Mascot Substation Project

Determination Report

February 2020

FIGURE 3: PROPOSED MASCOT SUBSTATION - MAGNETIC FIELD RESULTS (AT ONE METRE ABOVE GROUND)

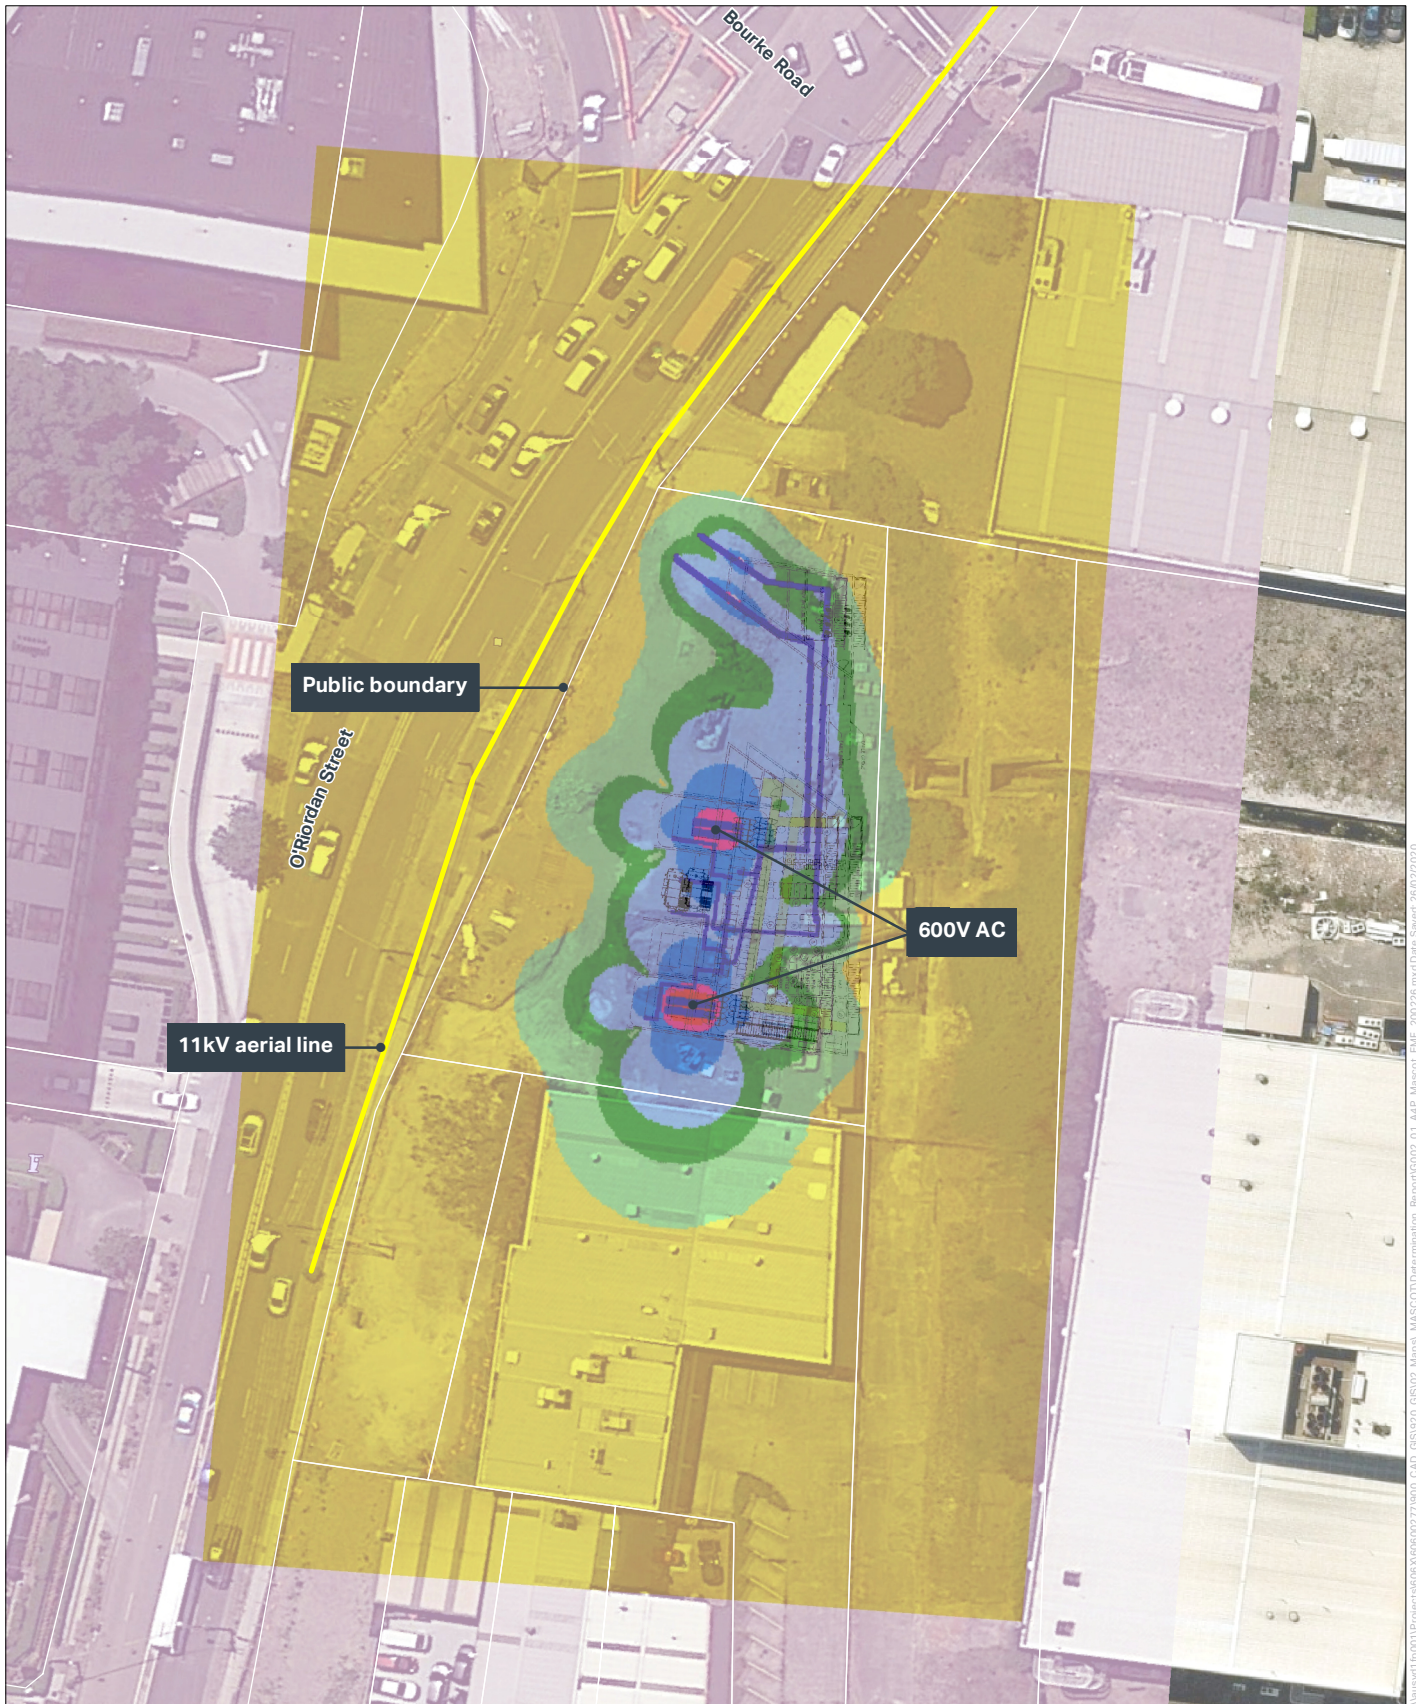
Submission (#5) expressed concern that the Proposal would affect the quality of life, such as health and safety of nearby residents due to the EMF produced. The submission also outlined concerns regarding socio-economic impacts and environmental impacts as a result of EMF.

Section 6.4 of the REF discusses the potential EMF impacts arising from the Proposal. The assessment has identified areas where the public or staff could be exposed to the magnetic fields of the Proposal, including inside the substation yard, near the public boundary and nearby residential buildings around the proposed Mascot Substation.

Section 6.4.1 of the REF identified that the strength of the magnetic field is greatest close to its source and diminishes rapidly with distance. The main magnetic field contribution from the substation is generated from the rectifier transformers and switchboards, which are located away from the public boundary. The possibility of adverse health effects due to the EMF associated with electrical equipment has been comprehensively studied worldwide over several decades. To date the scientific evidence does not establish that exposure to EMF found around the home, office or near power lines causes adverse health effects.

The proposed Mascot Substation was modelled to determine the likely magnetic fields at the nearest publicly accessible location to the equipment immediately adjacent to the western public boundary and southern boundary. Magnetic field levels contributed from the proposed substation at the western public boundary are considered negligible (less than 2 mG which is substantially less than the general public guideline limit of 2,000 mG). Magnetic field levels at the southern boundary are predicted to be up to approximately 50 mG. The levels are reduced to a negligible value (less than 2 mG) at 15 metres away from the southern boundary (**Figure 3**). Given this, levels in nearby residences would be negligible as they are located more than 15 metres away from the southern boundary, with the nearest residential receivers located 100 metres away.

Furthermore, mitigation measures as outlined in section 6.4.4 of the REF would be implemented to reduce the potential for EMF impacts.
